RIVER ESTATES PHASE 2: Blocks 44-46

MINOR VARIANCE APPLICATIONS

Re: Stormwater Management 42-64 Summersides Boulevard (Blocks 44, 45 & 46), River Estates (Phase 2), Fonthill

SUMMERSIDES BOULEVARD

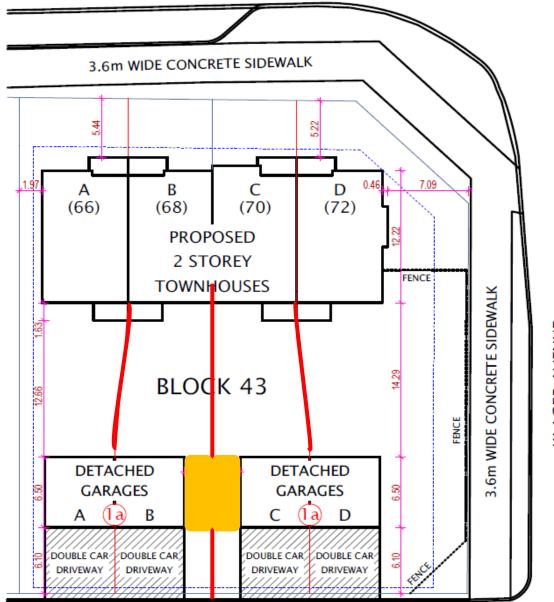
- The proposed back to front drainage that has been designed for the detached garages will be provided with a drainage apron swale system to direct stormwater from the proposed rear of the townhouse dwelling and away from detached garage. The drainage apron swale will direct stormwater around the proposed detached garage and out to Tokar Lane.

- 4. We confirm that the stormwater from heavy storm events will be adequately conveyed from the drainage apron to the side yard swales or sides of each proposed detached garage, without impacting the proposed detached garages.
